Application for Works Approval

Works Approval Number	W6518/2021/1
Applicant	Pilbara Iron Ore Company (Services) Pty Ltd
ACN	107 210 248
File Number	DER2018/001042-4~22
Premises	Yandicoogina Mine State Agreement Mineral Mining Lease ML274SA Shire of East Pilbara As defined by the Premises maps attached to the issued works approval
Date of Report	5 August 2021
Decision	Works approval granted

Yandicoogina – WFC3A Extension

Figure 2: Electrical conductivity within the proposed WFC3A extension. Vertical dotted line indicates tailings deposition into WFC (08/2014) and WFC3A (12/2016). Horizontal blue dotted line indicates SSGV for Marillana Creek.

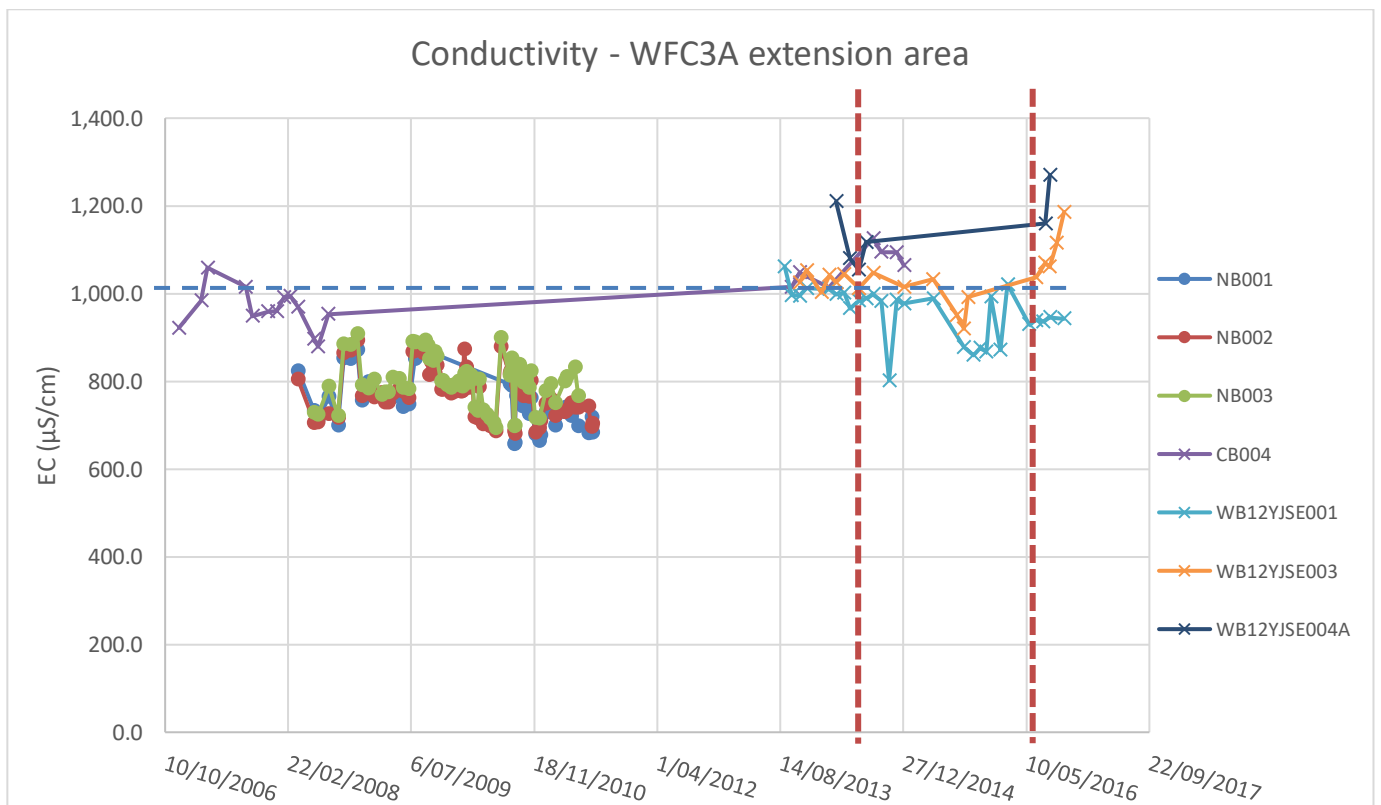
Electrical conductivity at JSE pit also show an increase above the SSGVs.

Figure 3: Monitoring bores location – JSE pit

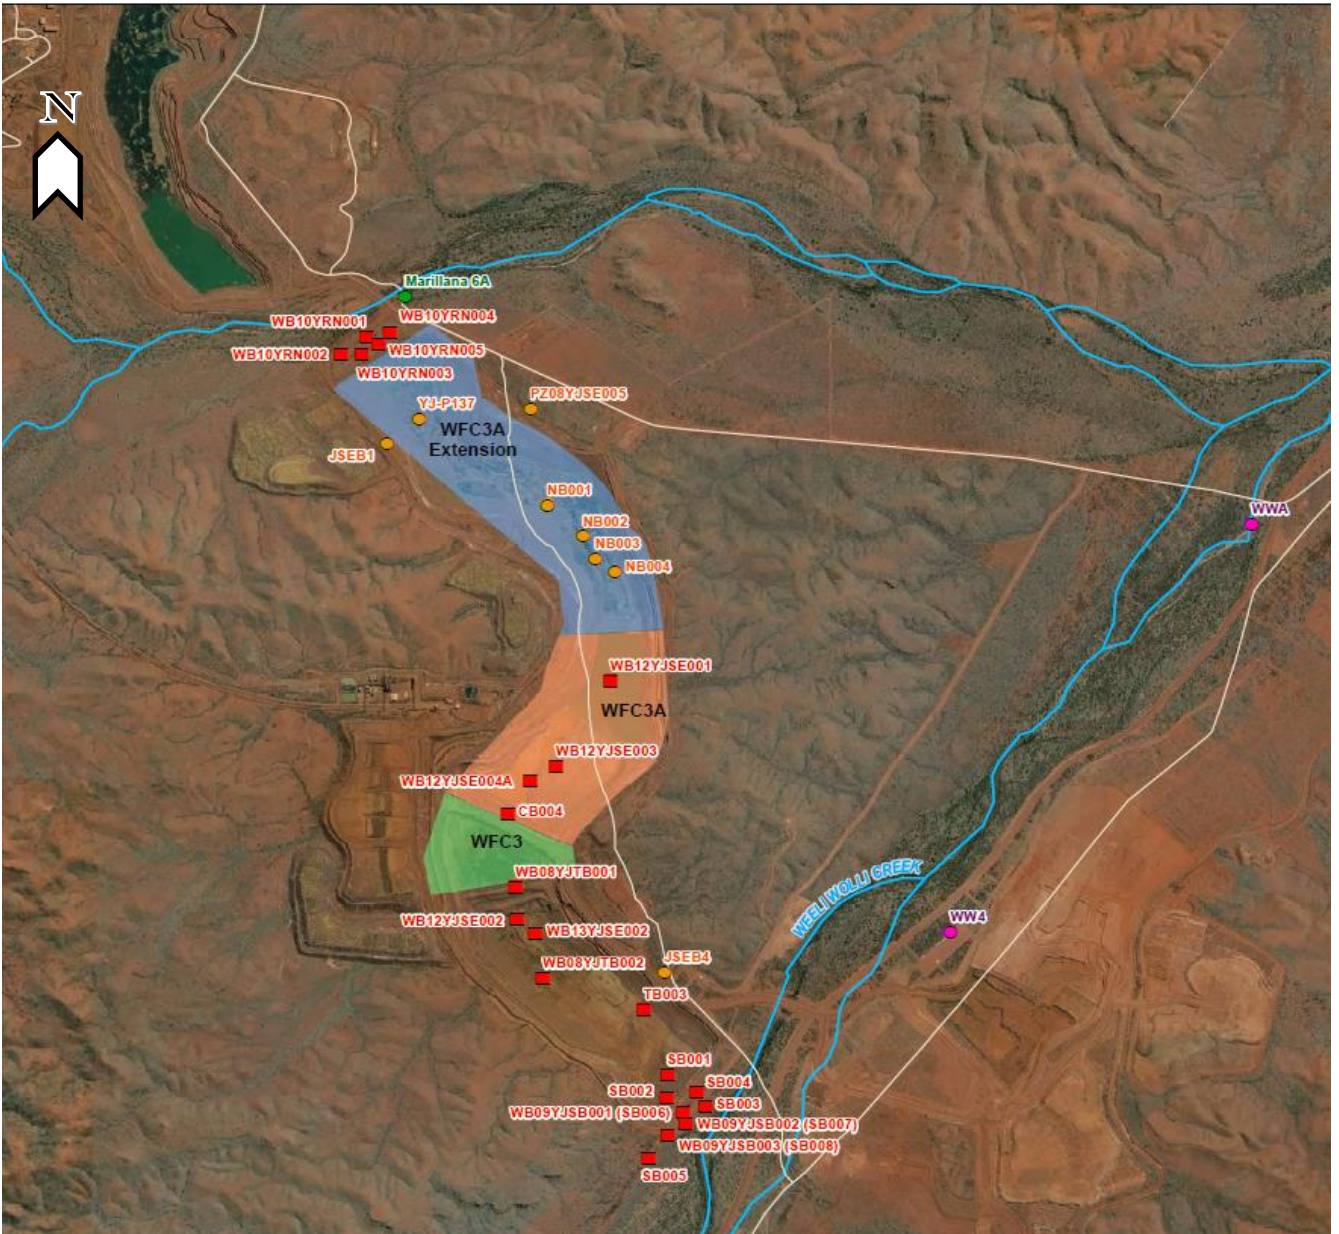
Limited groundwater quality information is available after deposition started into WFC3A pit in May 2016 as many monitoring bores located along JSE, pit were destroyed/decommissioned and not replaced. Available bores are shown in Figure 3.

Additional monitoring bores along JSE pit and piezometers will be also required to verify changes in groundwater level and monitor the potential movement of contaminants.

Figure 5: Distance to sensitive receptors – Flora

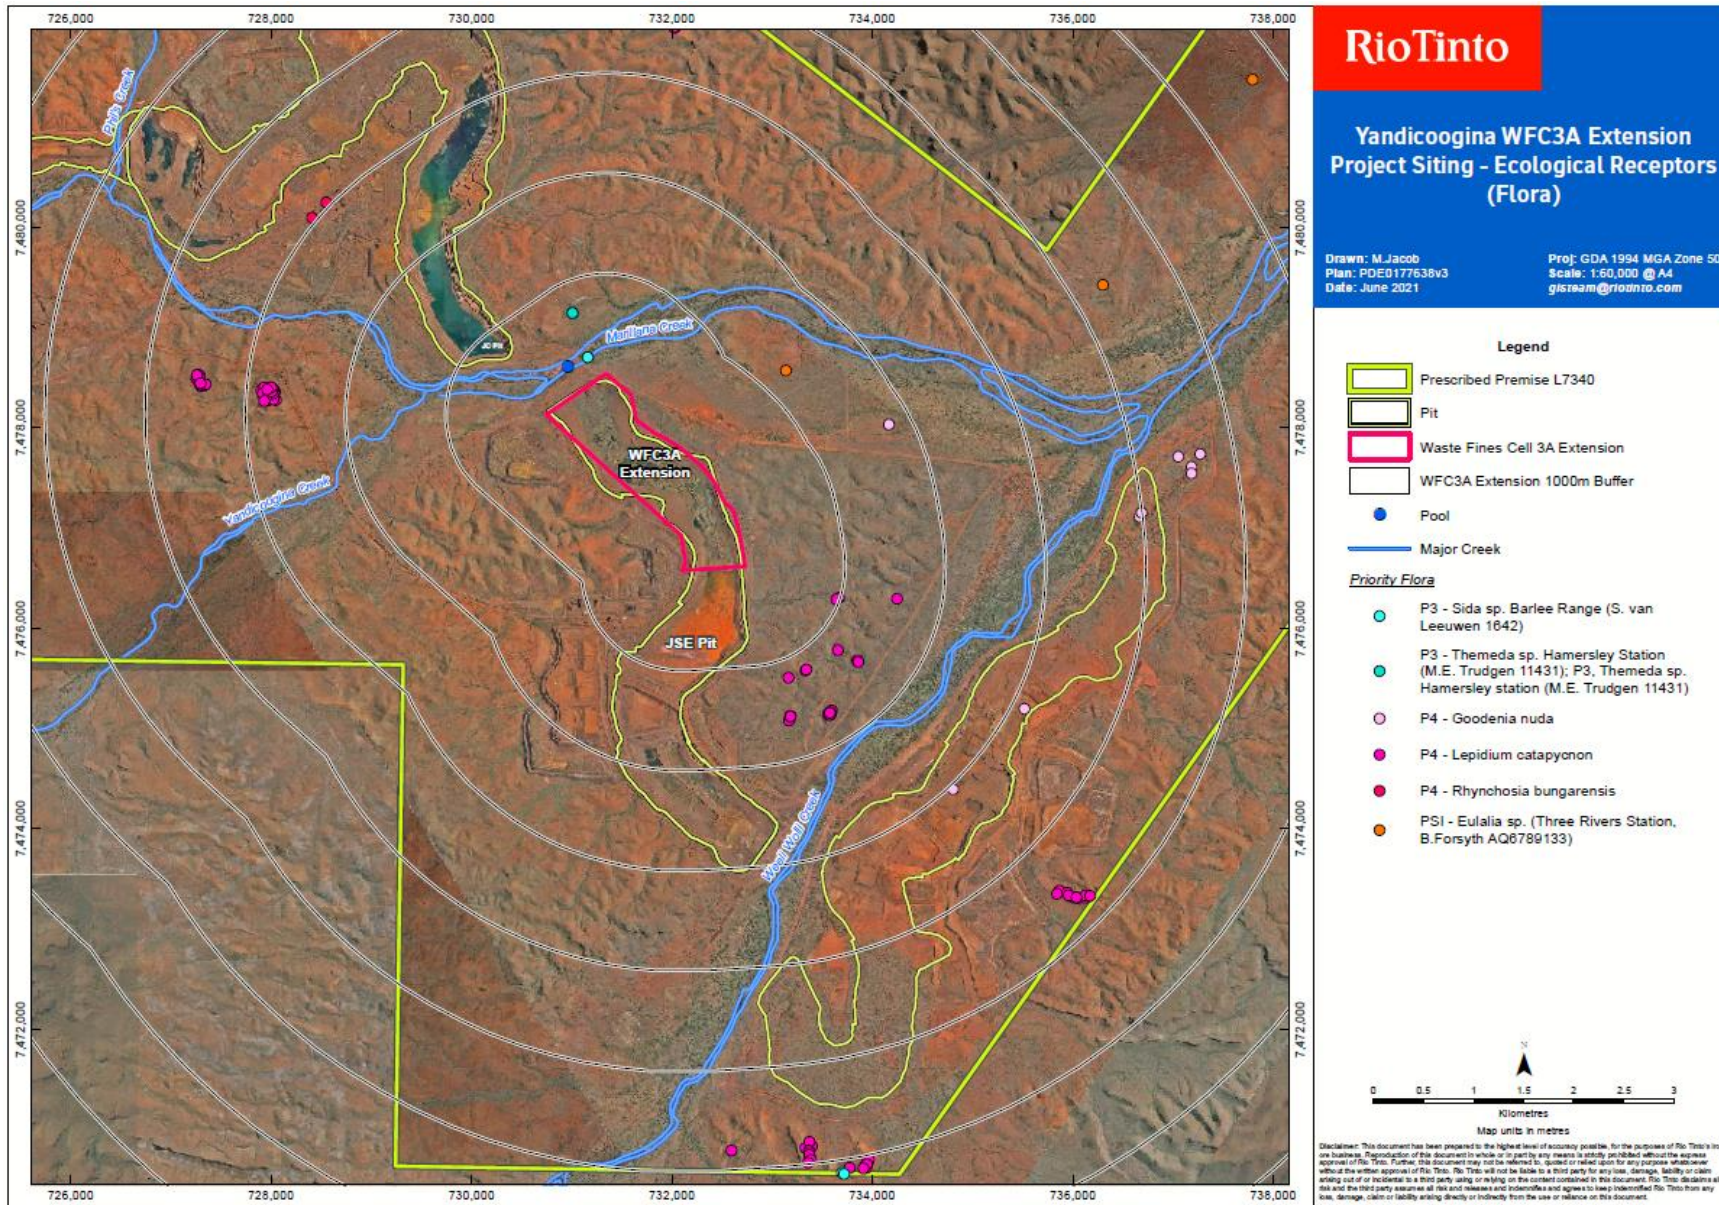
Condition	Summary of applicant's comment	Department's response
Condition 3	<p>Bore construction: As part of the Works Approval application, two new bores are proposed to be installed in the vicinity of the red crosses shown in Figure 5.</p> <p>Proposed Southern Bore</p> <p>The Licensee believes there are an adequate number of bores to the south of WFC3A Extension which provide sufficient coverage and target all aquifers. However, for DWERs information, the proposed monitoring bores to the south are primarily impacted by the nearby Weeli Wolli creek. This flows perennially due to discharge from Hope Downs 1 with a minor, but not insignificant contribution from Discharge Outlet 6. Flood events will occur irregularly and add to the water in the system. As a result, changes in the water chemistry will primarily be a downstream impact from Hope Downs 1.</p> <p>The Bore logs for listed bores are attached as Attachment 3.</p> <p>Proposed Northern Bore</p> <p>There are significant limitations to the installation of the bore required to the north with heritage and environmental constraints limiting access to the proposed location. Most notably, the assessment timeframe for relevant heritage and environmental approvals required to access the proposed locations in such close vicinity of Marillana Creek are expected to be years. As such, compliance with this particular location is not possible.</p> <p>The licensee proposes to redrill and replace Bore: Marillana 6A (731180E, 7478701N) as it would be using an existing track and minimise the ground disturbance. This is downstream of the initial proposed location and WFC3A Extension, so would theoretically be better at capturing any impact from the works.</p>	<p>The bore logs located south of WFC3A Extension were reviewed. The department concluded that most bores have very long screened intervals or they have a small screened interval at a large depth. None of the current bores will provide meaningful monitoring results for the gravel section. Given that environmental receptors (riparian vegetation and hyporheic fauna) are most likely to be affected by poor water quality in the shallow alluvial aquifer, the department requires bores with a short screened interval (less than 6 m long) constructed within this aquifer. Thus, the installation of a gravel bore at the south of WFC3A Extension remains.</p> <p>The department agrees to the reinstatement of Marillana 6A (731180E, 7478701N) as a gravel bore to the north of WFC3A Extension. However, this bore must have a short screened interval (less than 6 m long) constructed within the gravels.</p>
